Pushpanjali Residents Welfare Association,
(Reg. No.S-27904)

Subject: Mid-Term Review of Master Plan of Delhi –Transport/TOD Chapter

Proposed Transport Network from Pushpanjali, Bijwasan RWA

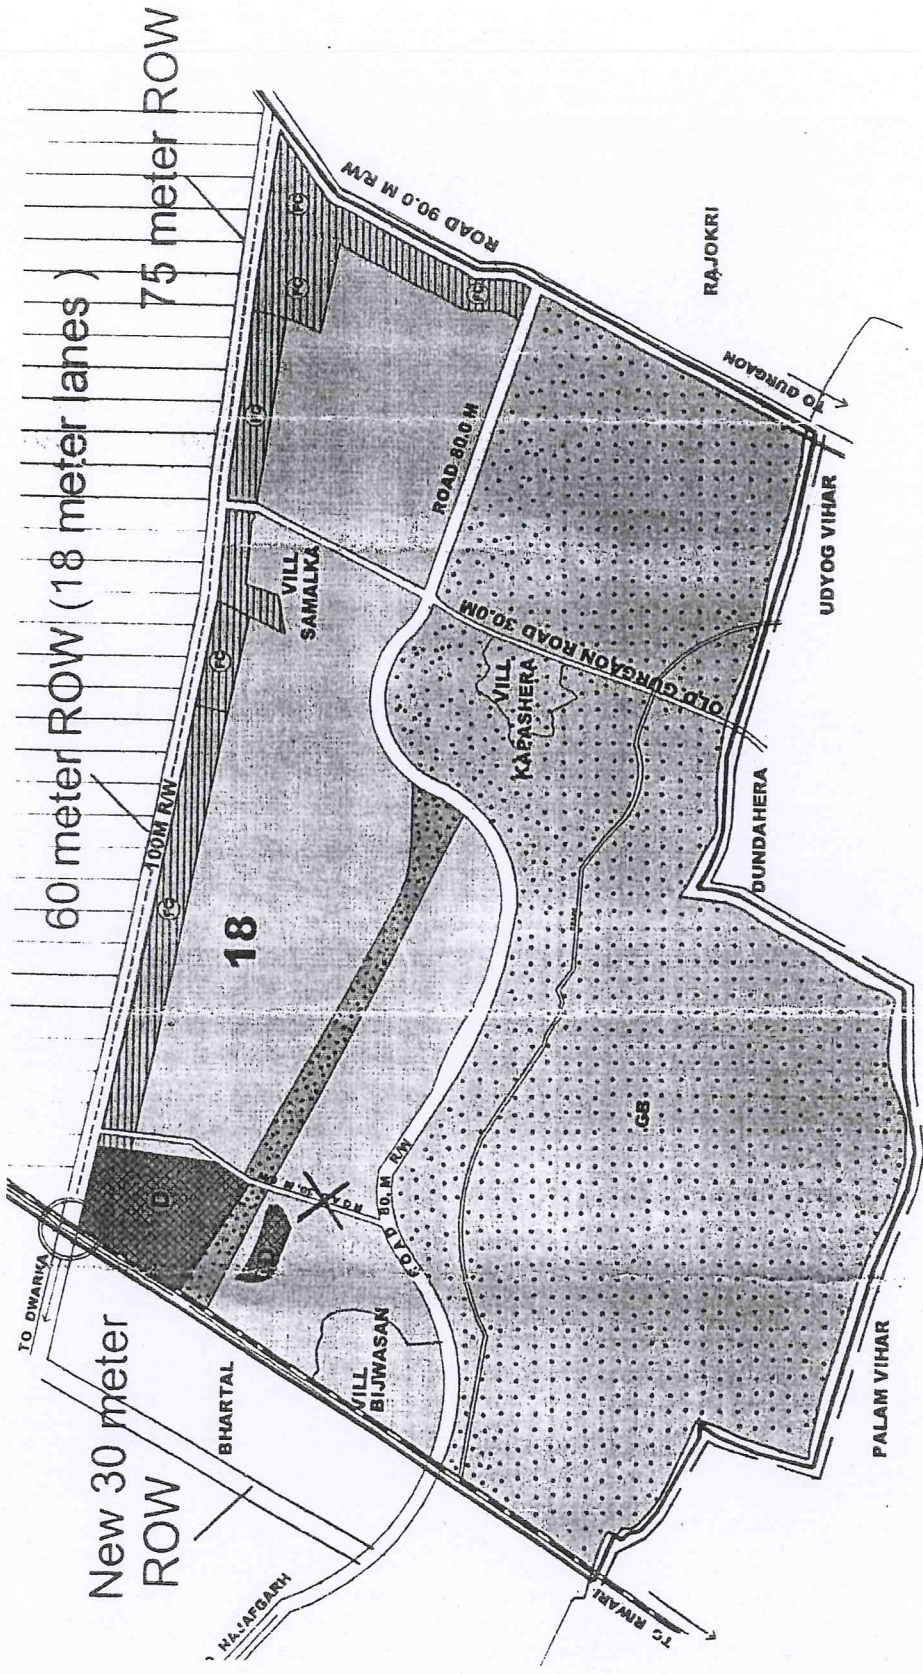
1. The existing road network between NH8 and Dwarka (known as Dwarka Link Rd) should be retained at 60 meters ROW instead of planned 100 meters ROW for the following reasons:

1.1 There is no need for two roads of 100 meter ROW and 80 meter ROW so close to each other feeding NH8 especially as traffic in the area will considerably reduce with proposed construction of new Western Peripheral Expressway providing direct link from Dwarka to Gurgaon and Manesar.

1.2 It is pertinent to note that the above proposed link roads connect Najafgarh, Bijwasan and Dwarka to NH8 which is currently a 60 meter ROW and will eventually expanded to 90 meter ROW. Hence feeder roads feeding the NH8 should be of lower ROW (ie. Less than 90 meter ROW) and not higher as proposed by the DDA plan. A 75 meter ROW has already been designed by UTTIPEC from NH8 to Samalkha Junction to cater for future increase in local traffic.

1.3 Even if the dual carriageway of the present 11 meters wide road each way needed to be widened to 18 meters (required for 100m ROW) this could easily be accomplished by merging the unused slip road on the airport side and part of green divider with the

Dwarka Link Road. Hence total ROW of road can be retained at 60 meter ROW and still cater for future traffic growth.

1.4 Additional traffic to/from Dwarka can be handled by connecting Dwarka to proposed 80 meter ROW Bijwasan-Najafgarh Road rather than increasing ROW on Dwarka Link Road. See our recommendation given in para 2 below.

1.5 If increase in ROW from 60 meters to 100 meters was carried out on the South side of Dwarka Link Rd. it will interfere with multistory housing of NSG Camp and also the MCD sanctioned houses along this side of the road. Acquisition of this land will be thus time consuming and costly for DDA.

1.6 Alternative increase in ROW on North (Airport) Side of Dwarka Link Road will be possible but this will have to be checked with airport operator DIAL. Earlier expansion of this road was found to be feasible on airport side as it was already owned by the Government.

2. A new 30m road is proposed between Bijwasan 80 meter ROW and existing Dwarka Link Road along the North side of the Rewari Railway Line for the following reasons:

2.1 The present plan of a road on south side of Bharat Petroleum depot is not feasible as distance from depot must be at least 100 meters for safety and security reasons as per Government Regulations. We would therefore recommend this road be relocated to an area along the opposite side of the Rewari Railway line to connect Dwarka with Bijwasan-Najafgarh Road and Palam Vihar.

2.2 Traffic from Dwarka to Gurgaon is currently using Dwarka Link road because there is no proper road connection between Dwarka and Bijwasan-Najafgarh Road. Besides increasing traffic on the Link Road this traffic currently must also go through Samalkha, causing further traffic congestion, as there is no provision to turn right, towards Gurgaon, at junction with NH8. The new proposed 30 meter ROW road would solve this problem.

2.3 The current plan to have a road on South Side of IOC depot will be time consuming and costly to DDA as it involves acquiring land and demolition of sanctioned houses in the area while north of the Rewari Railway line there is still open farm land.
